**Superior Town Center Phase 1 – Final Development Plan #1 (STC Ph1 FDP #1)  
Main Street Sidewalk and Parking Amendment (FDP 1-1-A)**

**Description of Proposed Revisions to the Sidewalk Paving and Planting Plans included in STC Ph1 FDP #1 (Reception #03369953 March 11, 2014)**

February 13, 2017

**Figure A**

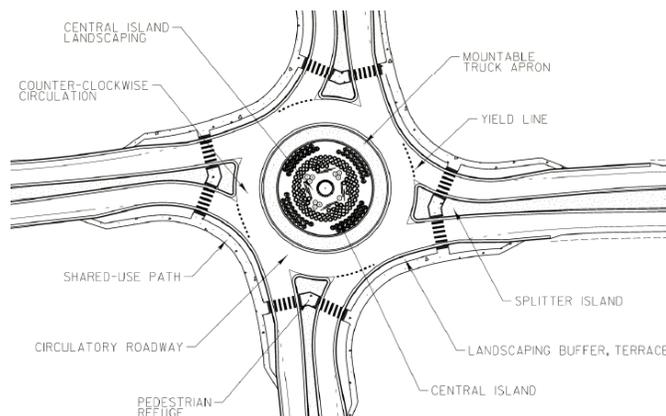
3. Roundabout Design: The pavers around the roundabout have been replaced with a generous tree lawn/shrub bed and adjoining 8' wide concrete sidewalk for safety and aesthetics. The shrub beds provide an impactful green landscaped gateway to Main Street and make the roundabout safe for pedestrians, keeping the edge of the sidewalk separated from the roundabout and preventing pedestrians from cross-cutting through the roundabout. This separation is a best practice for roundabout design and was overlooked in the approved design.
